#### **Addendum 98 – Regulation No. 99**

#### **Revision 3 - Amendment 2**

#### **Uniform provisions concerning the approval of gas-discharge light sources for use in approved gas-discharge lamp units of power-driven vehicles**

Figure 1  
Category D9S - Cap PK32d-9

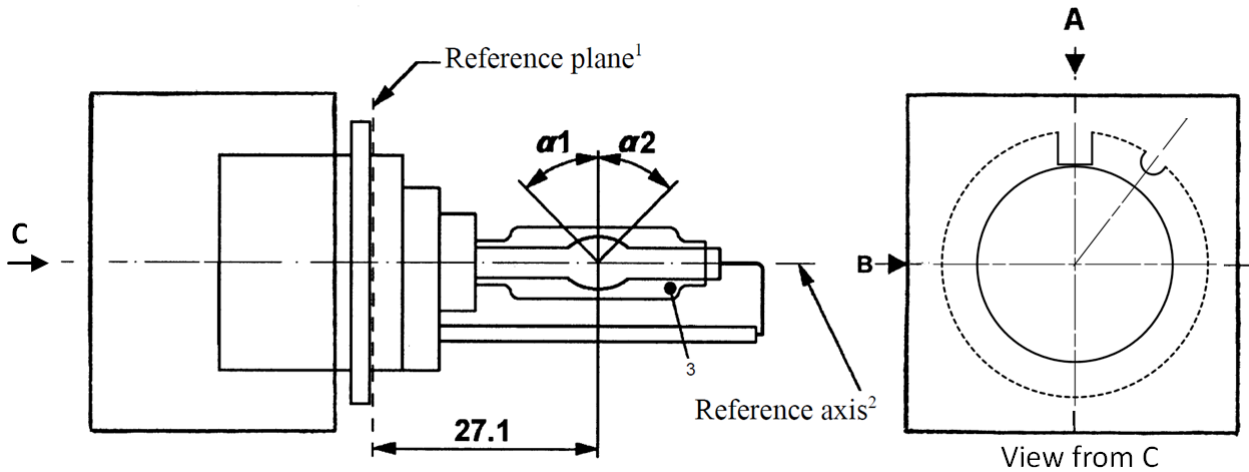
*Insert new sheets D9S/1 to 5, after D8S/5, to read (see following pages; one page per sheet):*

- <sup>1</sup> The reference plane is defined by the positions on the surface of the holder on which the three supporting bosses of the cap ring will rest.
- <sup>2</sup> See sheet D9S/2.
- <sup>3</sup> When measured at a distance of 27.1 mm from the reference plane and with respect to the mid-point of the inner bulb, the outer bulb shall have an eccentricity of 1 mm max.
